FDI	ENGINEERING CHANGE ORDER		ECO NO: 11-100
			Page 1 of 3
TITLE	DWG NO.	CURRENT REV	NEW REV
uEZGUI-RX 3.5	uEZGUI-RX 3.5	1.1	2

TITLE	DWG NO.	CURRENT REV	NEW REV
uEZGUI-RX 3.5	uEZGUI-RX 3.5	1.1	2

Schematic changes below;

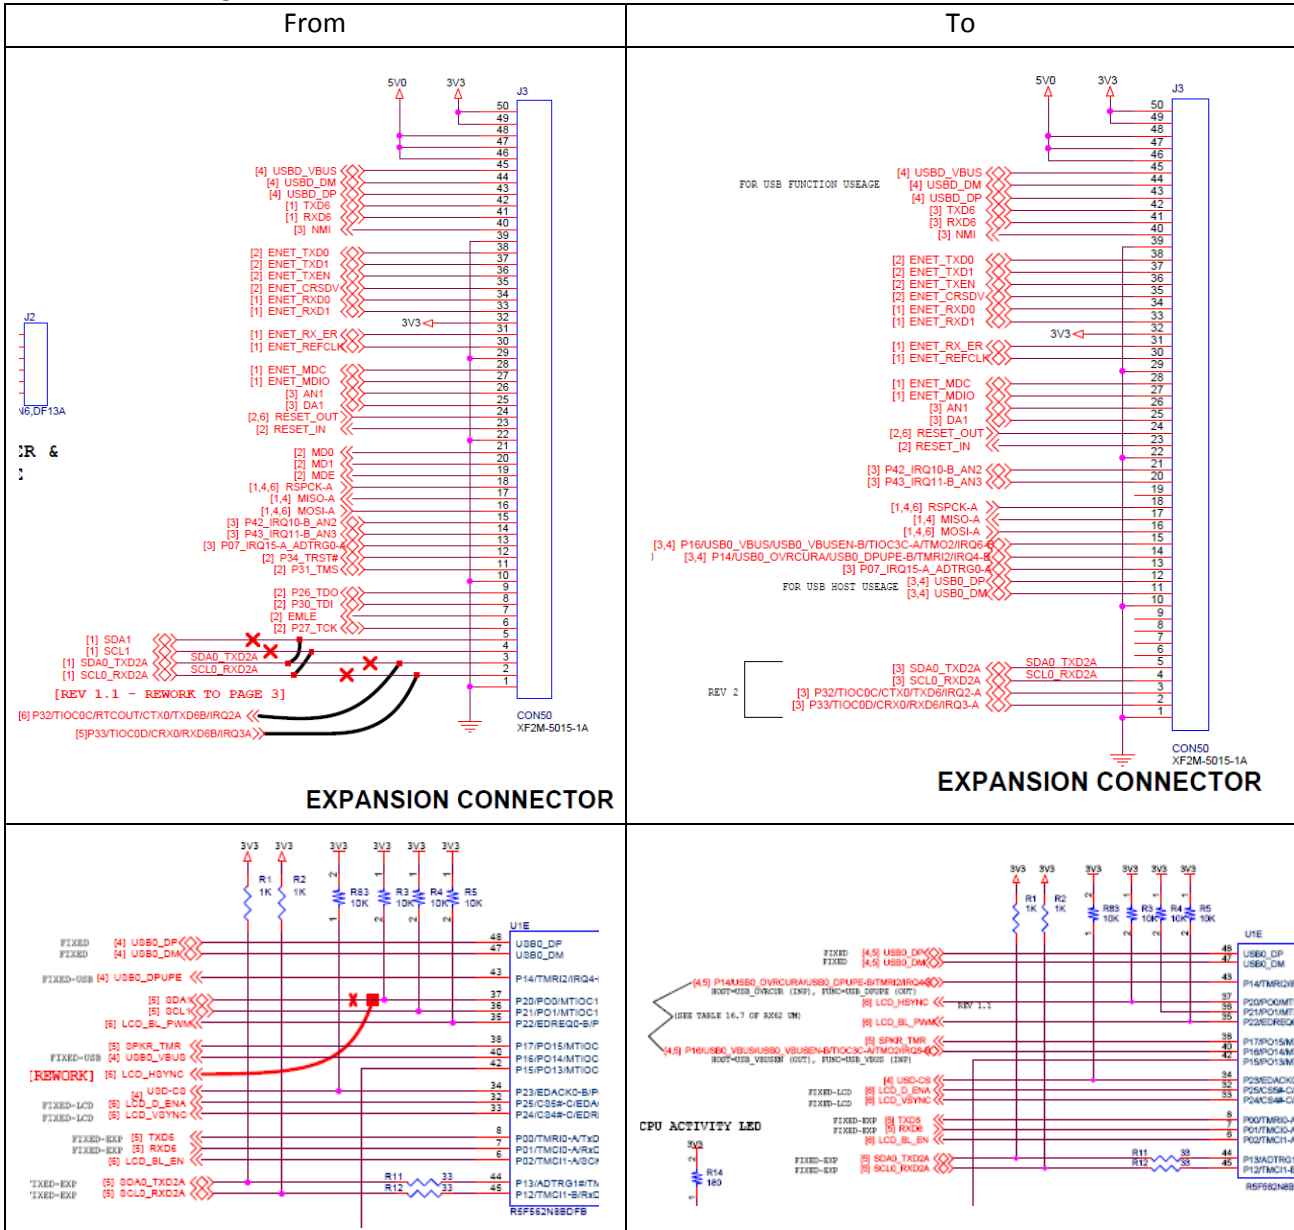
1. Implement ECO 11-099 into artwork
2. Disconnect the following signals from J3; (JTAG & MCU Config signals)
 - a. MD0 from pin 21
 - b. MD1 from pin 20
 - c. MDE from pin 10
 - d. P34_TRST# from pin 12
 - e. P31_TMS from pin 11
 - f. P26_TDO from pin 9
 - g. P30_TDI from pin 8
 - h. EMLE from pin 7
 - i. P27_TCK from pin 6
3. Move the following connections on J3; (make room for USB signals)
 - a. P42_IRQ10-B_AN2 from pin 15 to pin 21
 - b. P43_IRQ11-B_AN3 from pin 14 to pin 20
4. Add the following connections to J3; (USB Signals)
 - a. P16/USB0_VBUS/USB0_VBUSEN-B/TIOC3C-A/TMO2/IRQ6-B to pin 15
 - b. P14/USB0_OVRCURA/USB0_DPUPE-B/TMRI2/IRQ4-B to pin 14
 - c. USB0_DP to pin 12
 - d. USB0_DM to pin 11

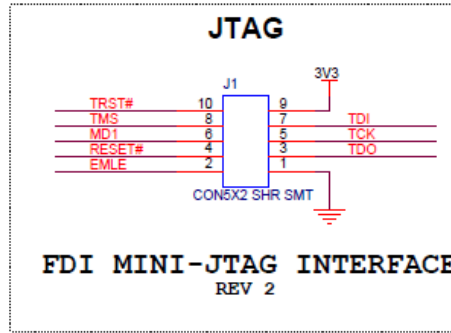
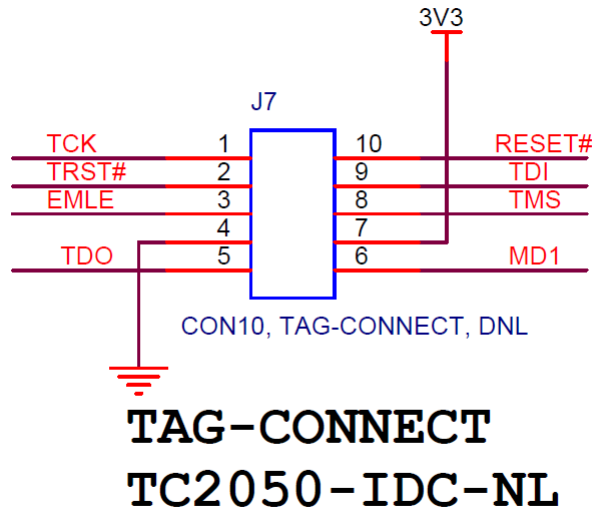
5. Change J1 from 14pin 7x2 0.1" shrouded header to 10pin 5x2 2mm shrouded header as shown below:
